**PRELIMINARY DRAINAGE REPORT  
FOR  
ESTEBAN RODRIGUEZ SUBDIVISION  
EL PASO COUNTY, COLORADO**

October 2024

Due to the nature and volume of comments provided additional new comments may be generated on the re-submittal.

PCD File No.: **SP245**

PROPOSED DRAINAGE MAP  
ESTEBAN RODRIGUEZ SUBDIVISION  
JOB NO. 25277.00  
10/22/2024  
SHEET 1 OF 4

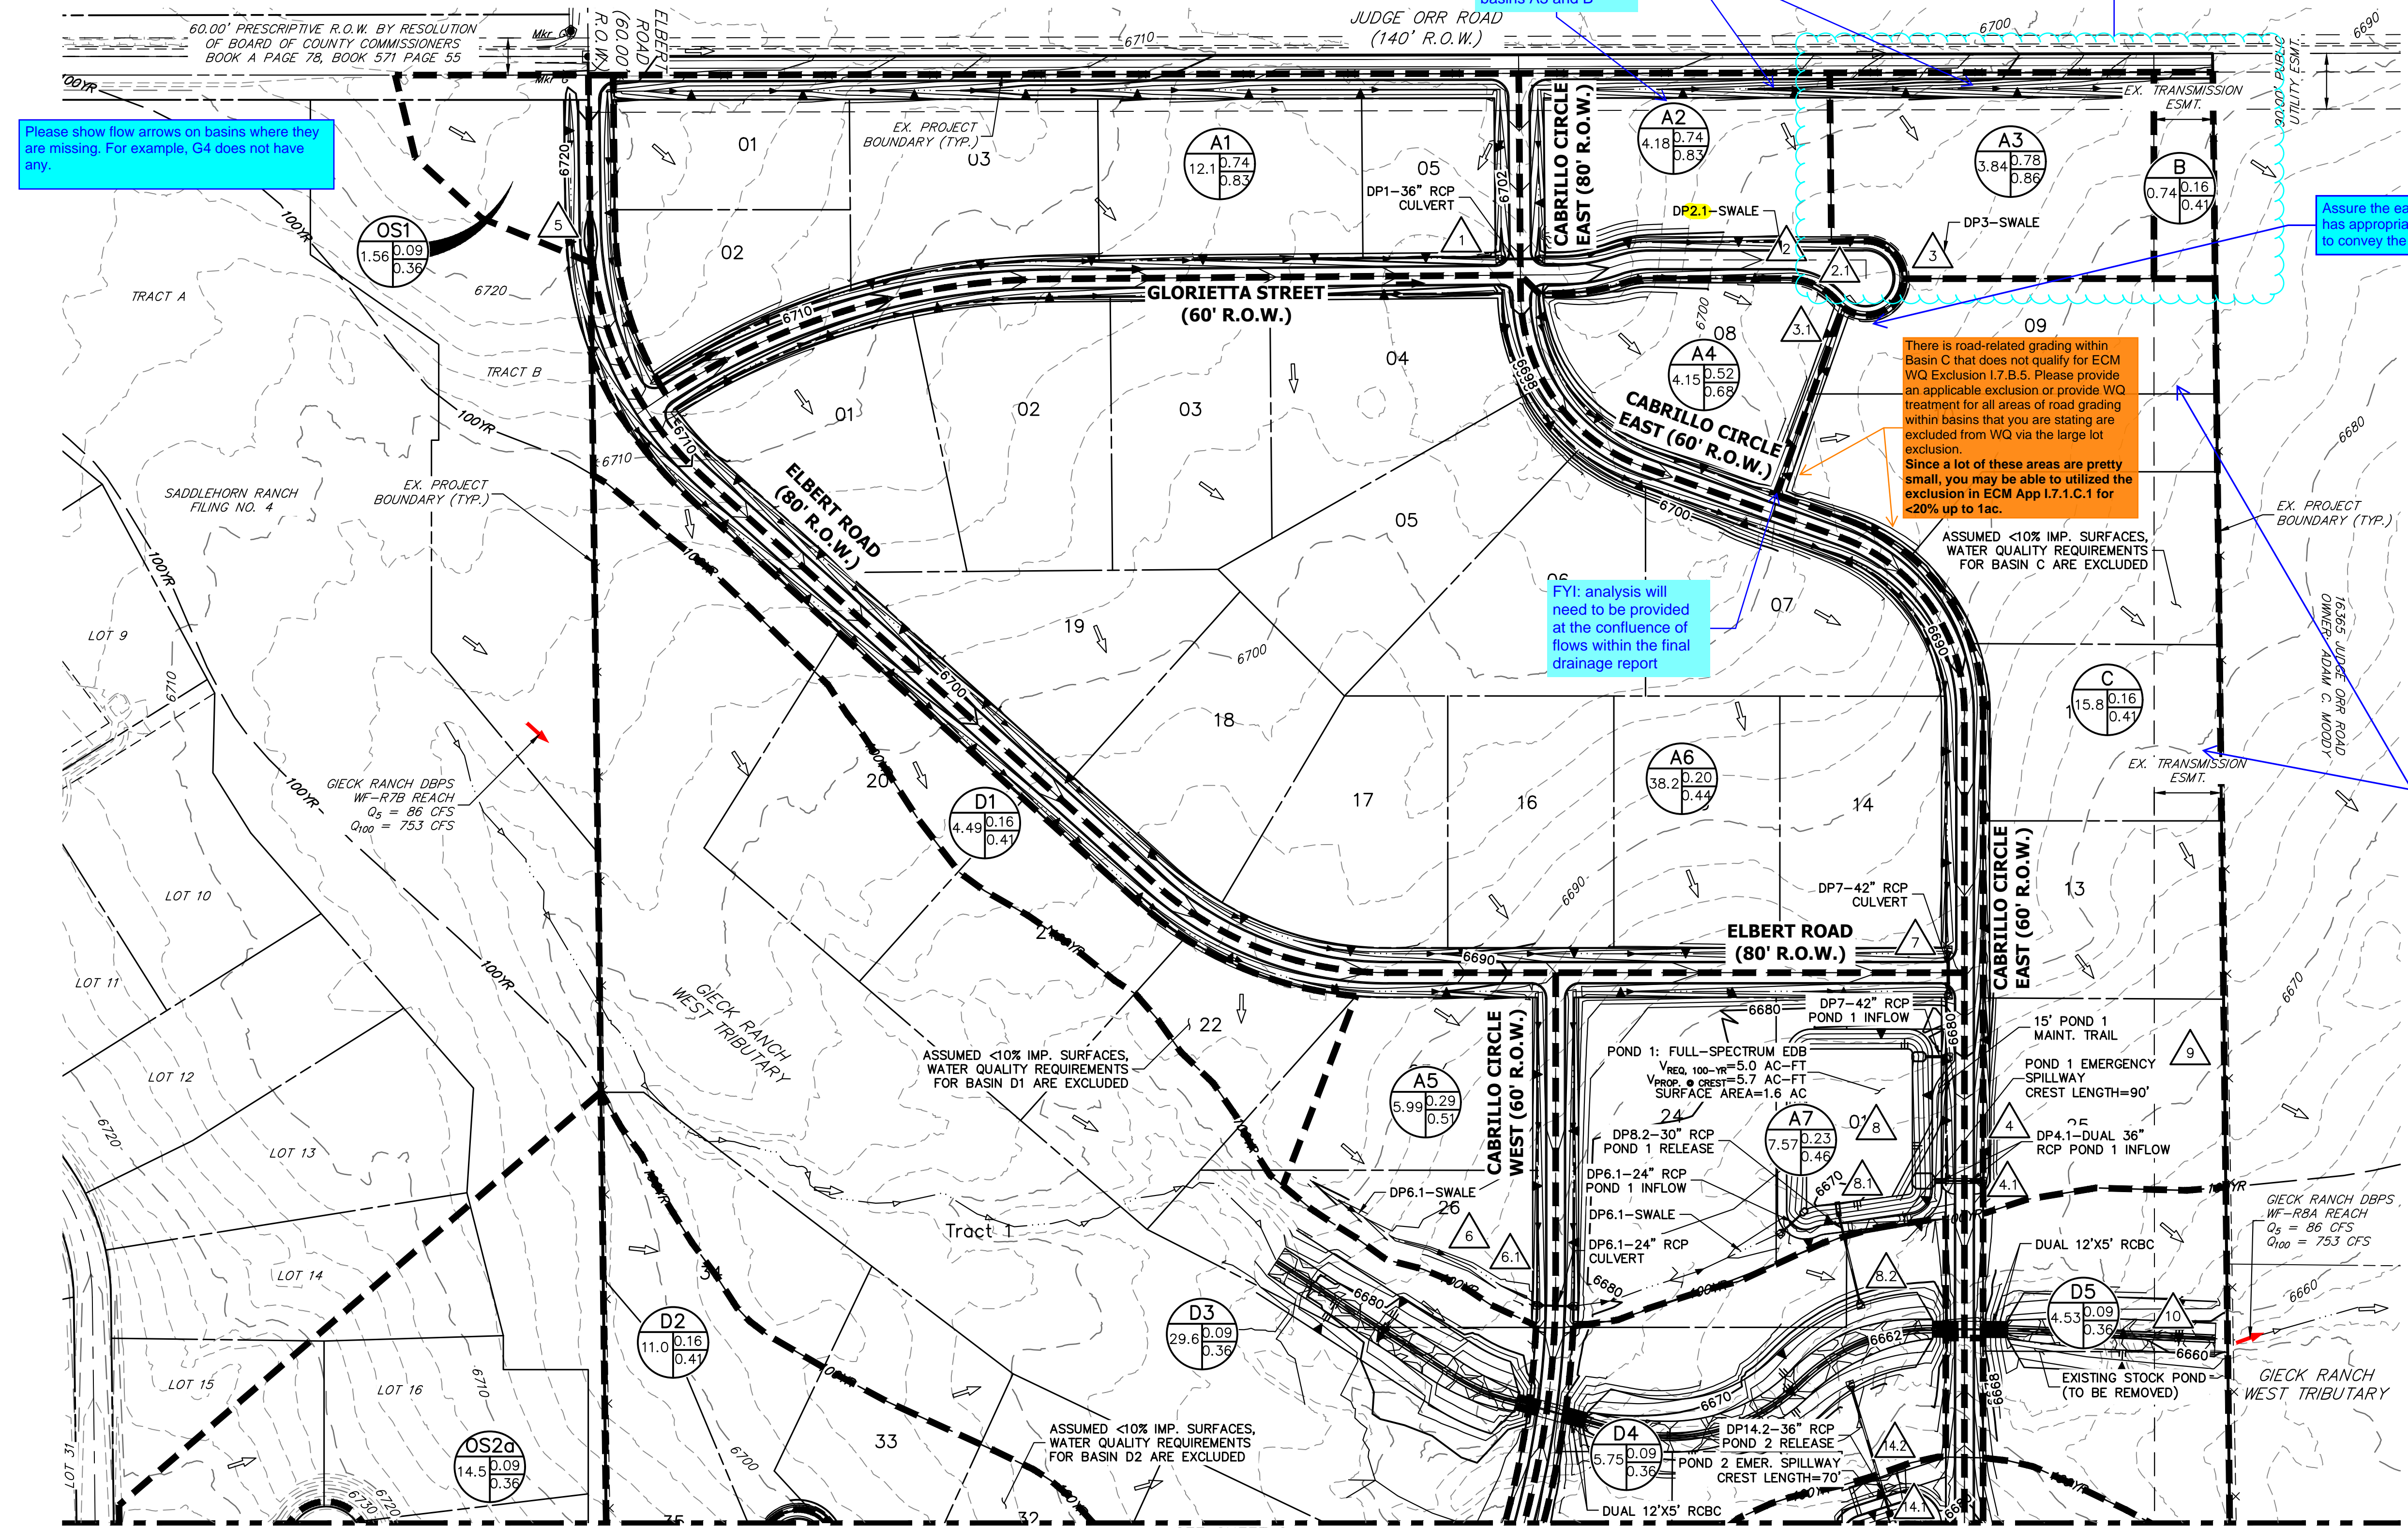
Rounding error, should be 35

PROPOSED DRAINAGE MAP  
 ESTEBAN RODRIGUEZ SUBDIVISION  
 JOB NO. 25277.00  
 10/22/2024  
 SHEET 2 OF 4

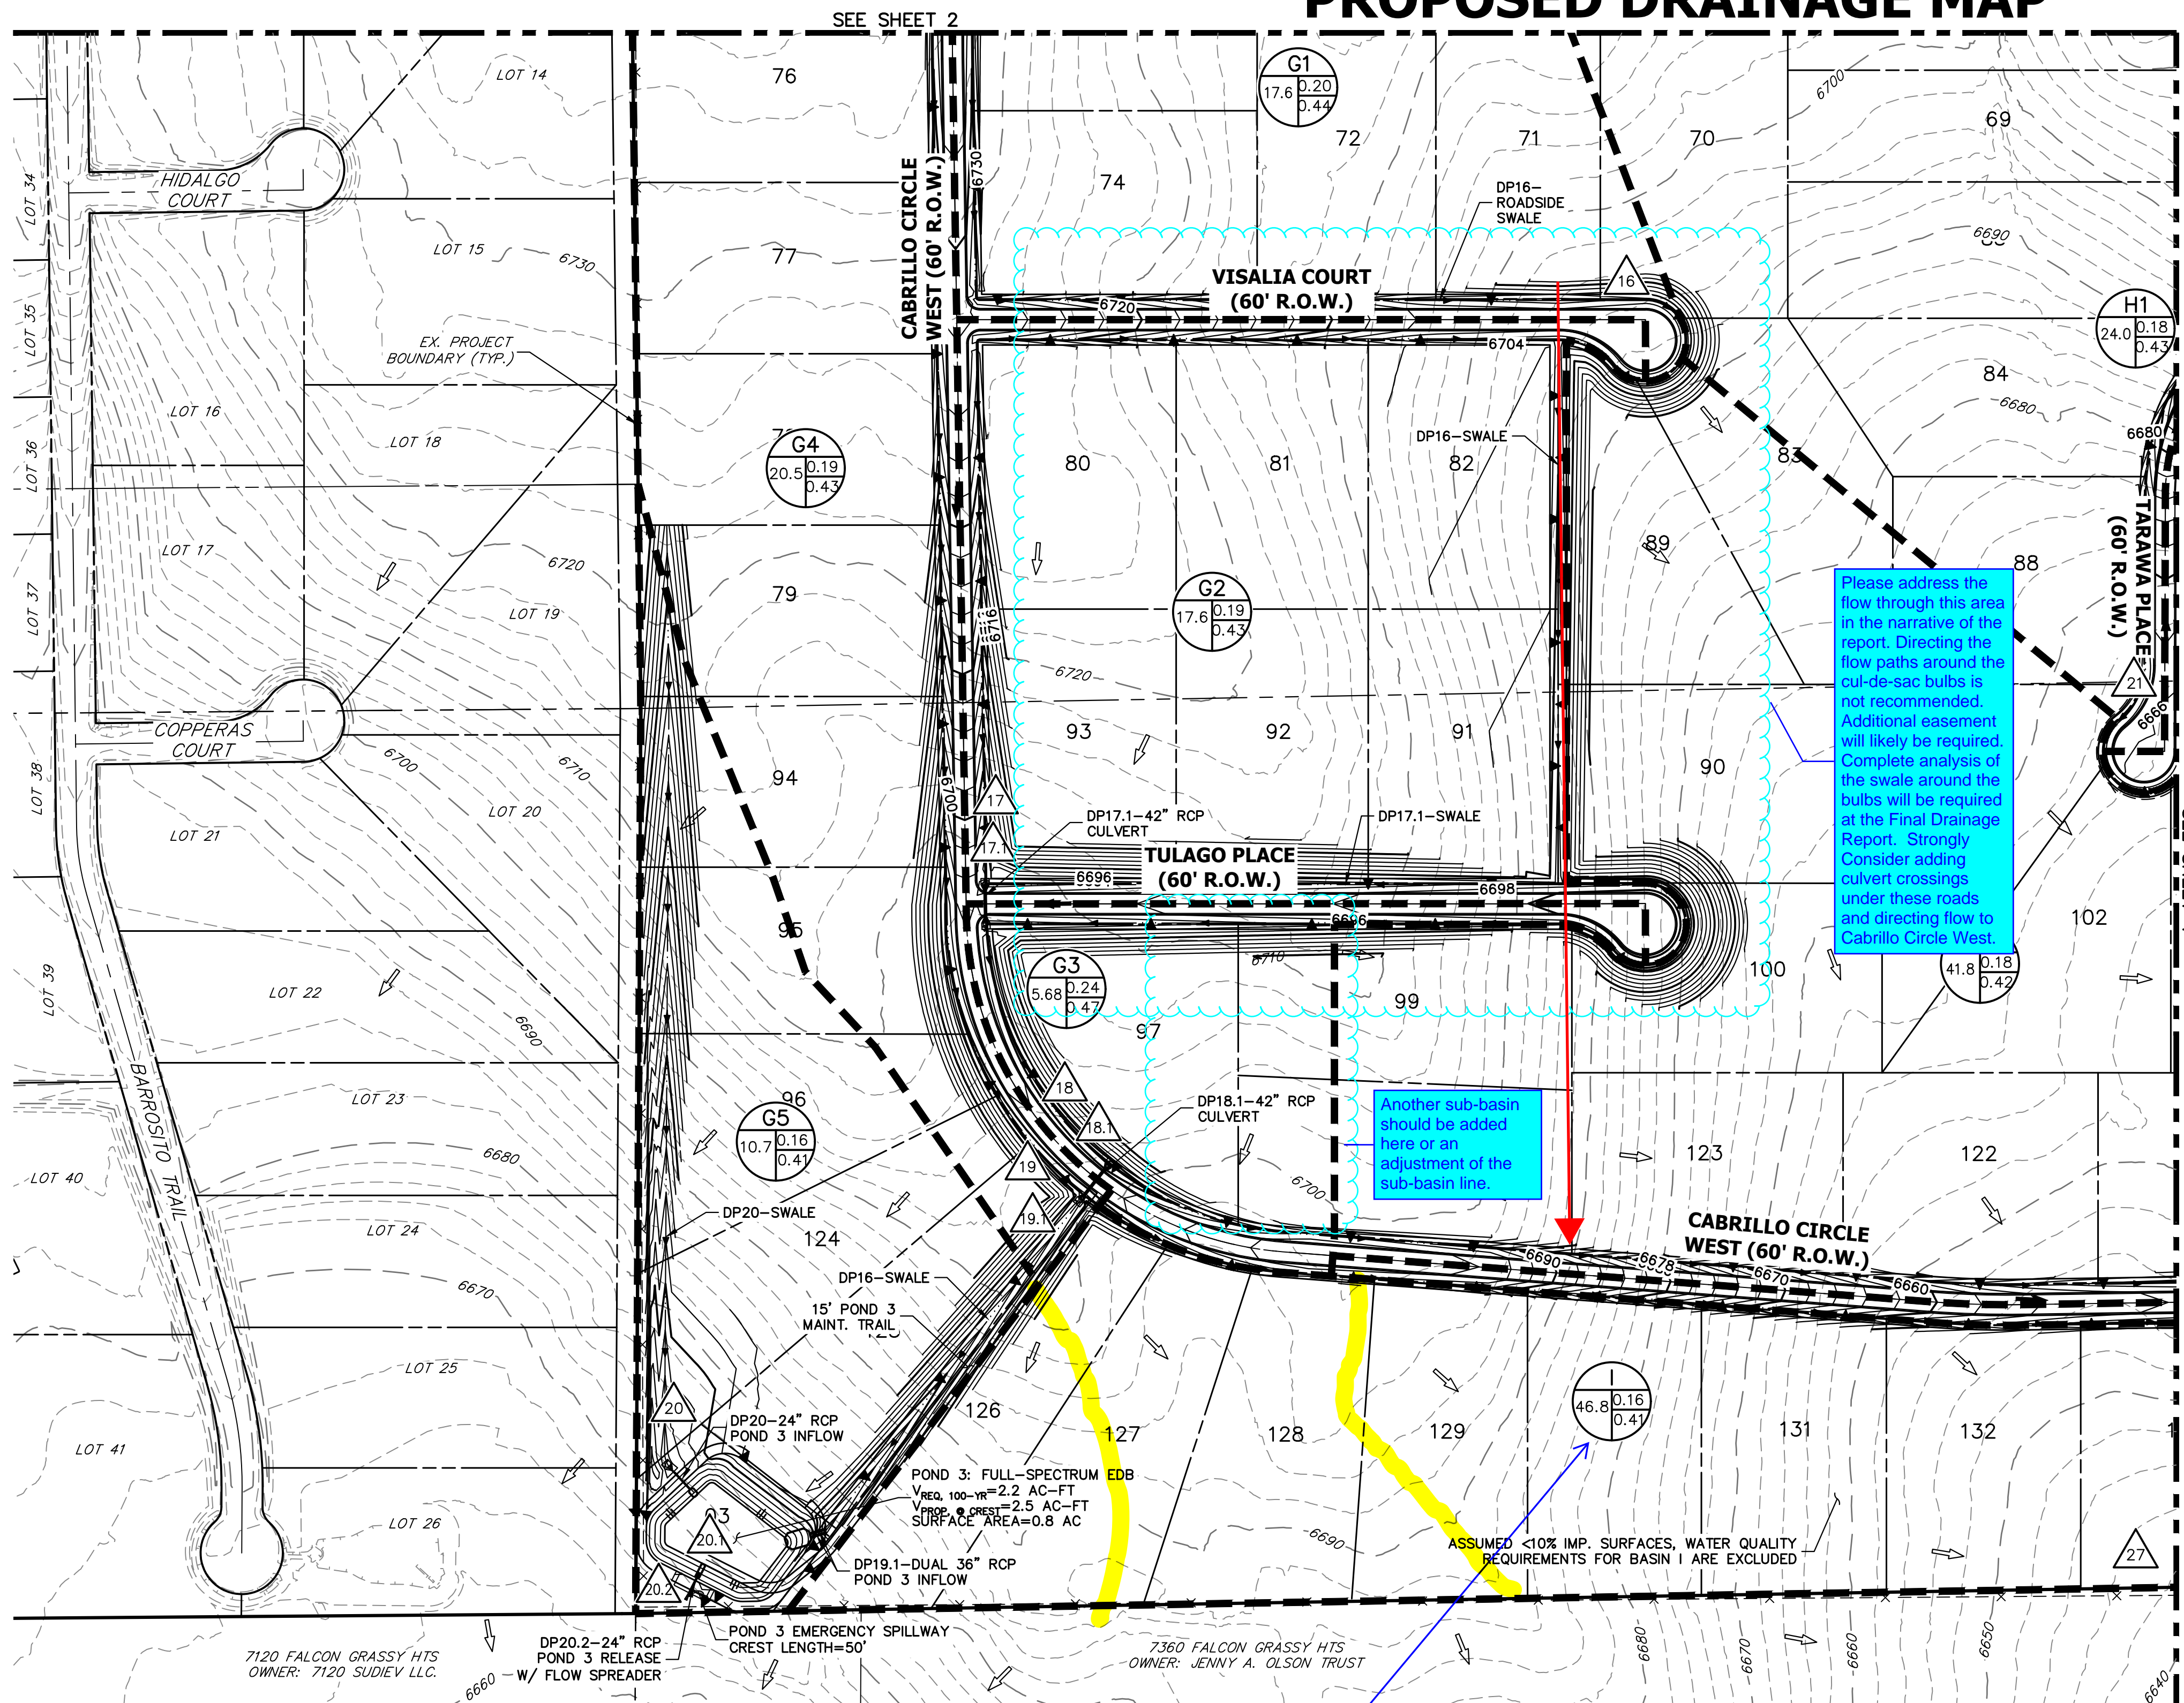
Please address the flow through this area in the narrative of the report. Directing the flow paths around the cut-de-sac bulbs is not recommended. Additional easement will likely be required. Complete analysis of the swale around the bulbs will be required at the Final Drainage Report. Strongly Consider adding culvert crossings under these roads and directing flow to Cabrillo Circle West.

PROPOSED DRAINAGE MAP  
ESTEBAN RODRIGUEZ SUBDIVISION  
JOB NO. 25277.00  
10/22/2024  
SHEET 3 OF 4

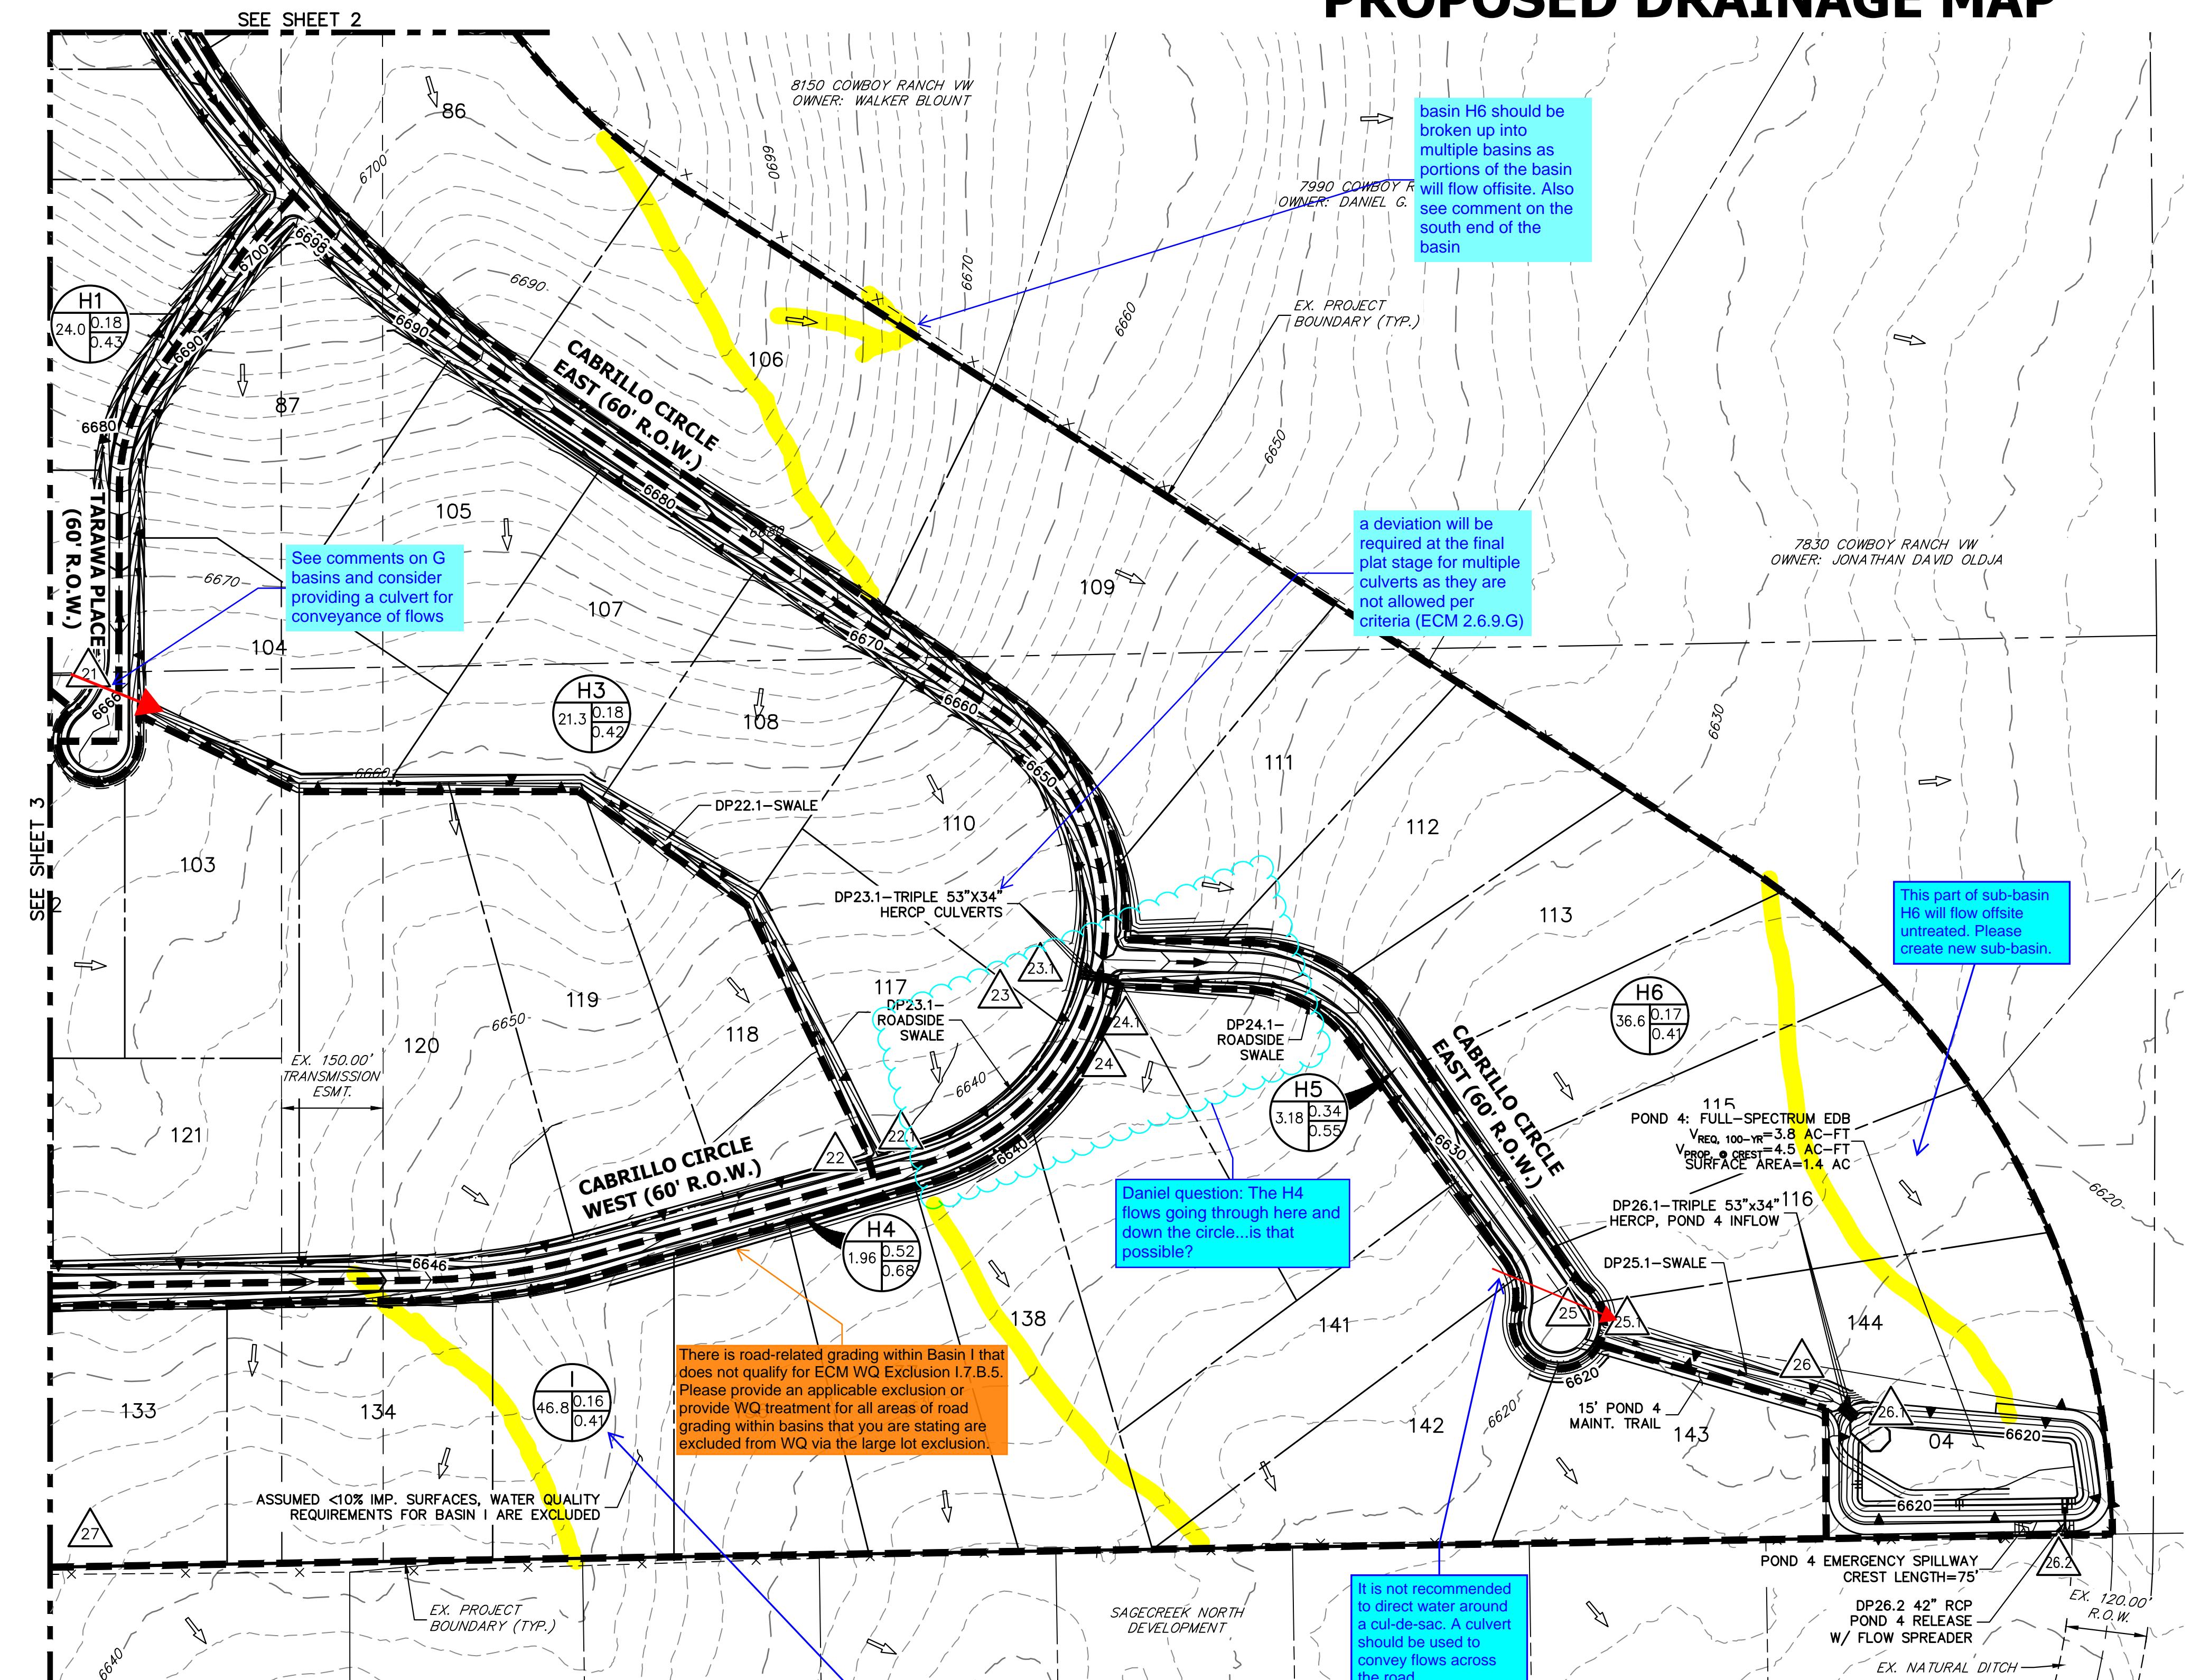
basin H6 should be broken up into multiple basins as portions of the basin will flow offsite. Also see comment on the south end of the basin
